PROPOSED CONSERVATORY DISPLAY UNIT for SOLARFRAME Ltd
at SOLARFRAME, DAVEY ROAD, GOLDTHORPE, ROTHERHAM S63 0JF

Your REF. 2016/0202

Solarframe Conservatory Display Proposals DRWG. 784/2R
 Daray Road, Poldhorne, MINE SHAFT DETAILS 28/03/16
 Gordon Stevenson Ch. Arch. Tel 01302 891411
 email stevenson_93@sky.com

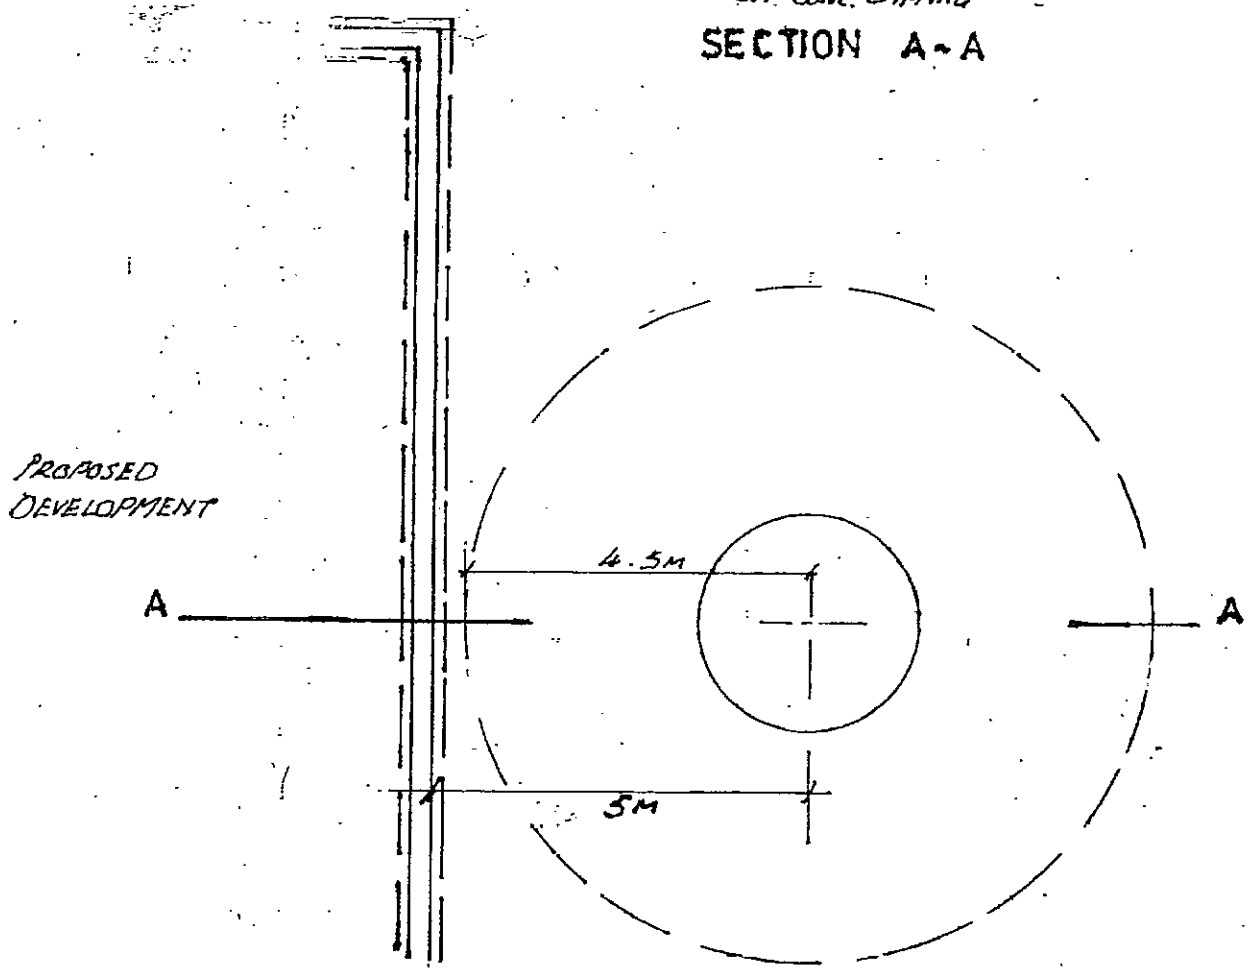
Assuming suitable ground bearing conditions the foundations of the proposed conservatory building 5m at their nearest point from the mine shaft centre, & outside the exclusion zone would be excavated to a 900mm minimum depth below finished ground, reference to my sectional drawing on which a 4.5m stand off area is ringed indicates the development proposal appears to satisfy the conditions required by the SYM Advisory Service

AMENDMENTS		
DATE	NO	DESCRIPTION
29/03/16	R	MAKE DIMENSION OF BUILDING 5M FROM MINE SHAFT
